Eastern Creek Business Hub

Design Guidelines

For: Western Sydney Parklands Trust

Date: ~~12th February, 2014~~ **10 March, 2017**

Figure 53 52: Development Control Plan - Lot 2 (not to scale)

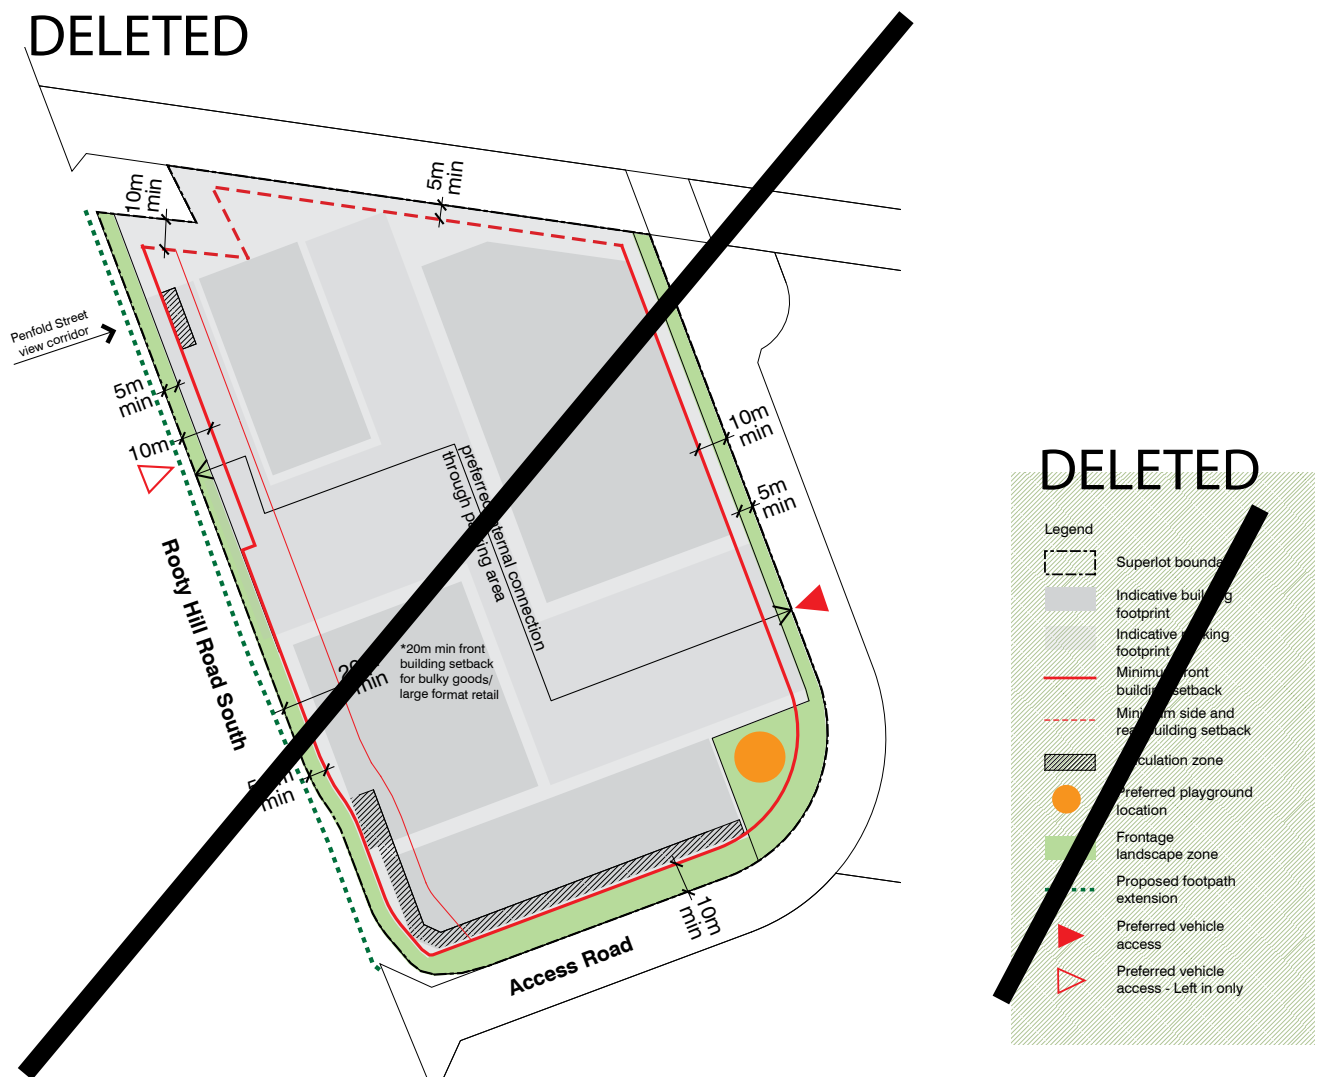
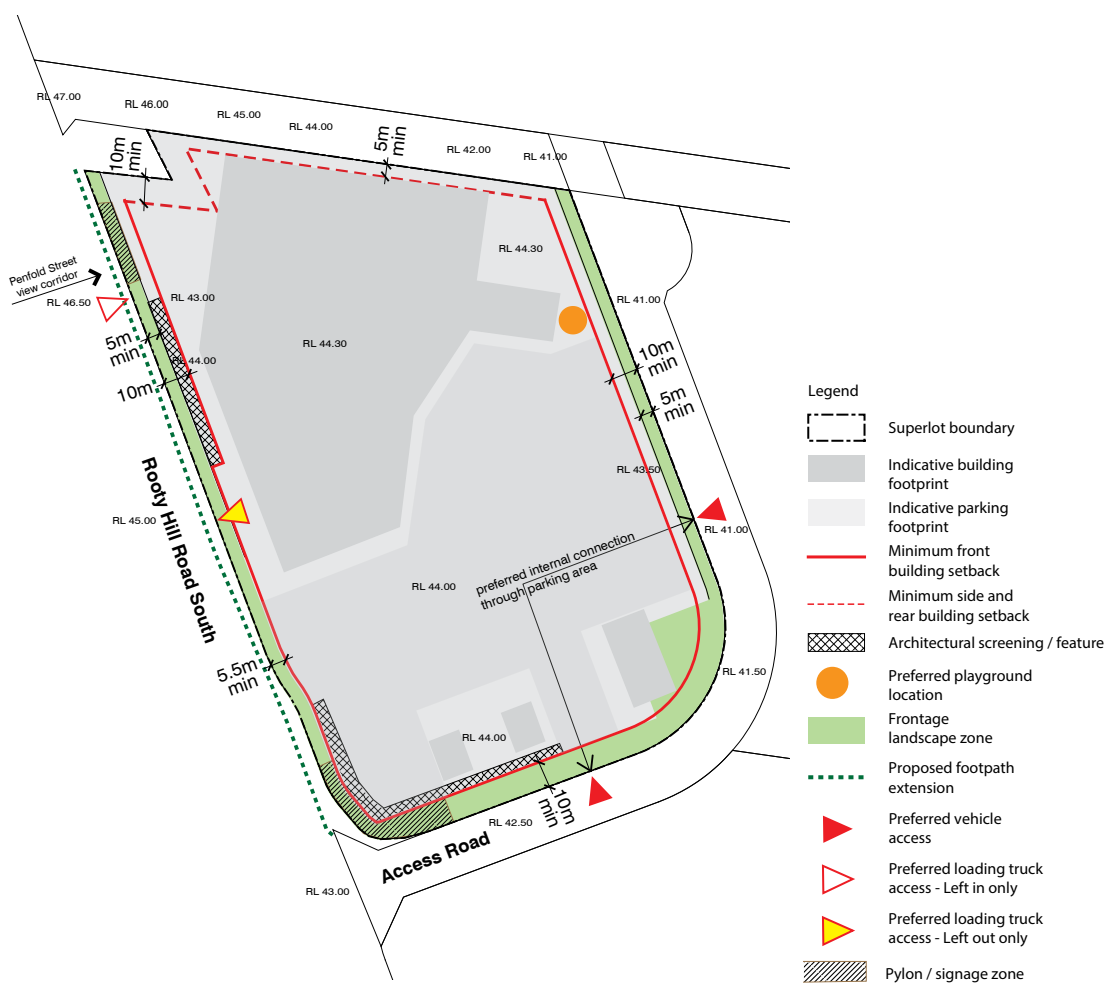
DELETED

INSERTED

Figure 52: Development Control Plan - Lot 2 (not to scale)

Figure 53: Architectural screening can be used to articulate the streetscape, and create a positive desired architectural profile

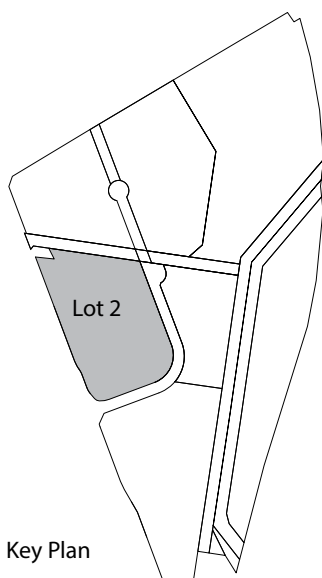
INSERTED
